MISSOURI HIGHWAYS AND TRANSPORTATION COMMISSION

INDEX OF DRAWINGS

I-70 MISSISSIPPI RIVER BRIDGE
MISSOURI APPROACH

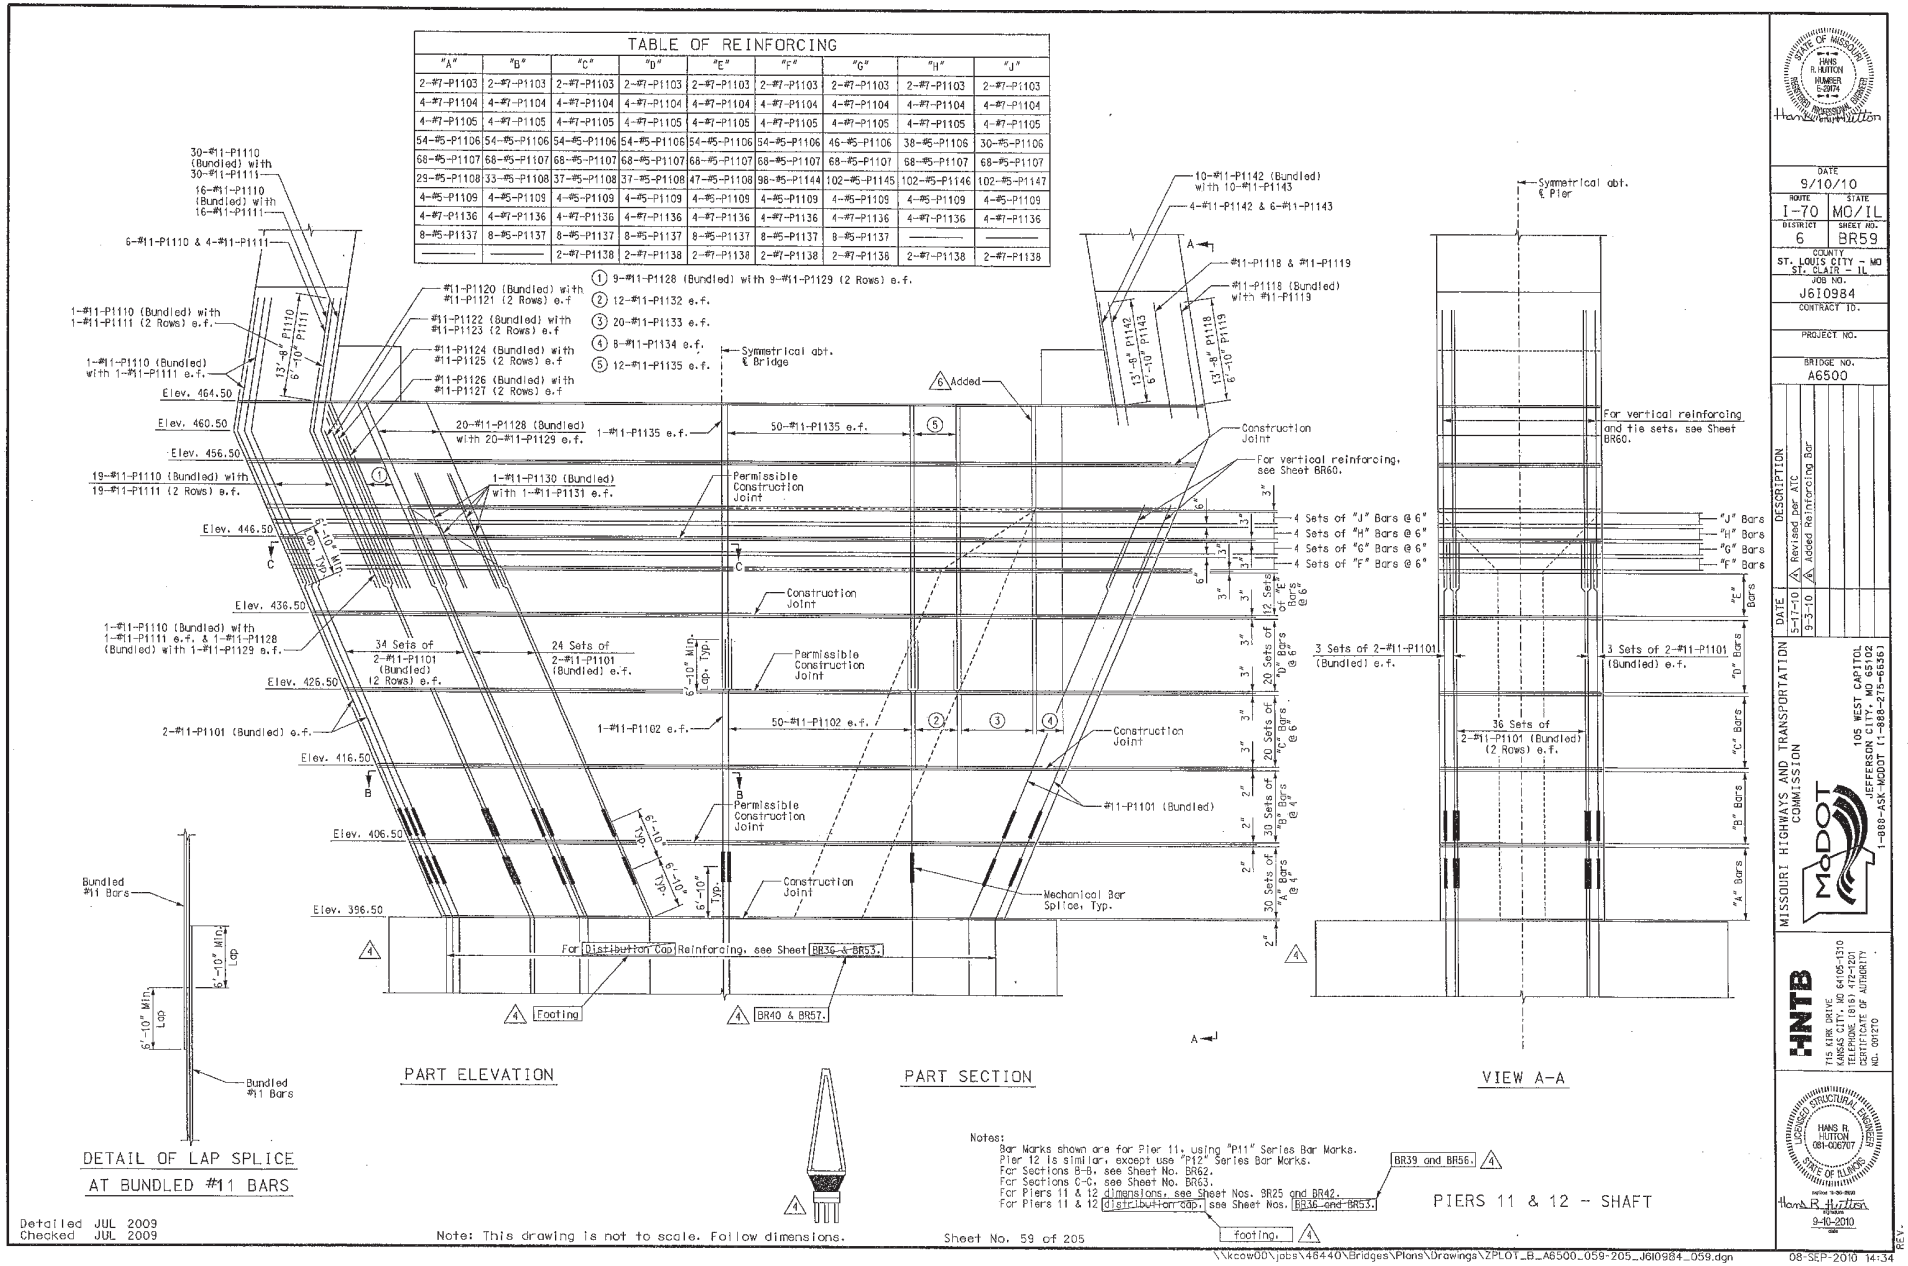
Attached are plan sheets 8, 59, 185, 186 & 203 which should be added to MTA's ATC set of plans. These changes are result from MTA's RFI #058 where MTA asked for confirmation of the orientation of certain rebar that appeared would protrude from the concrete in Piers 11 & 12 at about elevation 450'.

#11-P1101 (Bundled)
Mechanical Bar Splice, Typ.
6'-10" Typ.
For Distribution Cap Reinforcing, see Sheet BR36 & BR53.
4 Footing
4 BR40 & BR57.
6 Added
10-#11-P1142 (Bundled) with 10-#11-P1143
4-#11-P1142 & 6-#11-P1143

#11-P1118 & #11-P1119
#11-P1118 (Bundled) with #11-P1119
13'-8" P1142
6'-10" P1143
13'-8" P1118
6'-10" P1119
For vertical reinforcing, see Sheet BR60.
4 Sets of "J" Bars @ 6"
4 Sets of "H" Bars @ 6"
4 Sets of "G" Bars @ 6"
4 Sets of "F" Bars @ 6"
12 Sets of "E" Bars @ 6"
20 Sets of "D" Bars @ 6"
20 Sets of "C" Bars @ 6"
30 Sets of "B" Bars @ 4"
30 Sets of "A" Bars @ 4"
"J" Bars
"H" Bars
"G" Bars
"F" Bars
"E" Bars
"D" Bars
"C" Bars
"B" Bars
"A" Bars
3 Sets of 2-#11-P1101 (Bundled) e.f.
36 Sets of 2-#11-P1101 (Bundled) (2 Rows) e.f.
Symmetrical abt. ℄ Pier
For vertical reinforcing and tie sets, see Sheet BR60.
Bundled #11 Bars
6'-10" Min. Lap
DETAIL OF LAP SPLICE AT BUNDLED #11 BARS
PART ELEVATION
PART SECTION
VIEW A-A
Notes:
Bar Marks shown are for Pier 11, using "P11" Series Bar Marks.
Pier 12 is similar, except use "P12" Series Bar Marks.
For Sections B-B, see Sheet No. BR62.
For Sections C-C, see Sheet No. BR63.
For Piers 11 & 12 dimensions, see Sheet Nos. BR25 and BR42.
